Access Compliance Report

Public Rights-of-Way

(Curb Ramps)

Intersection ID: 10020183	Main Street: AUDUBON_PARK_DR	Cross Street: PIEDMONT_PARK_DR	Location: E
ADA ID: DE55B74DBF81	Ramp Type: Directional1	Initial Pass/Fail: Fail	Overall Compliance: No
Codes/Mitigation Info/Possible Solution		Field Measurements/Component Compliance	
Severity Score: 1.25

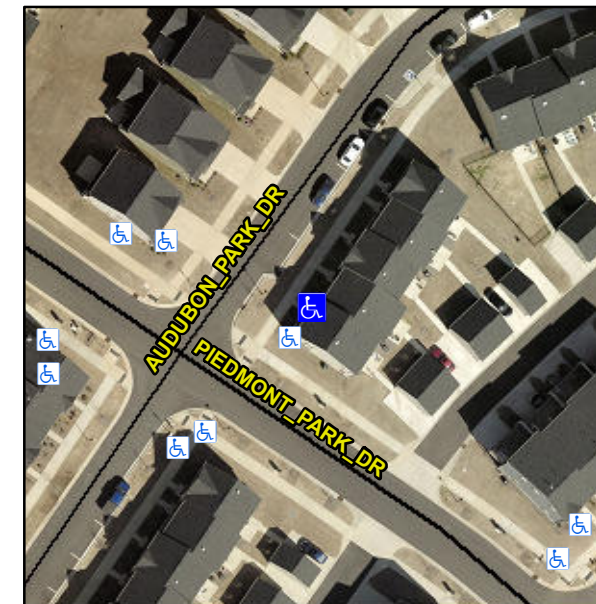
R304.5.3

Remove & Replace Entire Ramp.
